Re: Application for a Permissive Change Filing with FCC ID:. EW780-8015-04 IC: 1135B-80801504

The purpose of this document is to describe all the changes that are made on **BASE Unit** to the new designed family models **CS6124-2** n from the original CS6114-2 in order to meet the requirements.

1.1 CS6114-2 BS RF section layout

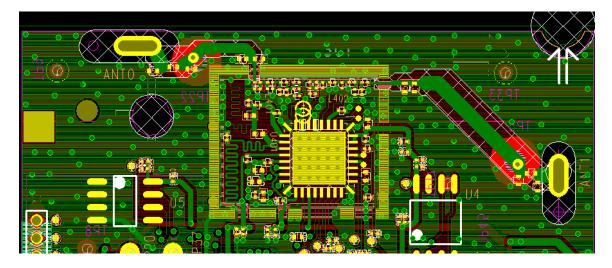
In order to add Answer machine function to Base unit, Changes of Base Unit from the original model to the new designed model:

- Antenna's location and size is different ;
- Antenna matching circuit and layout is different
- BS PCB size is different;
- Baseband circuit/layout is different for those ITAD related circuit
- Flash IC W25Q40CSIG (U4) is added
- The EEPROM IC changed from 416A-2GLI to BC24C16B (U5).
- Mask IC is changed from DCE58VT211AEZC to DE56VT555QEZA (U2)
- Answering machine function added.
- LED display is added
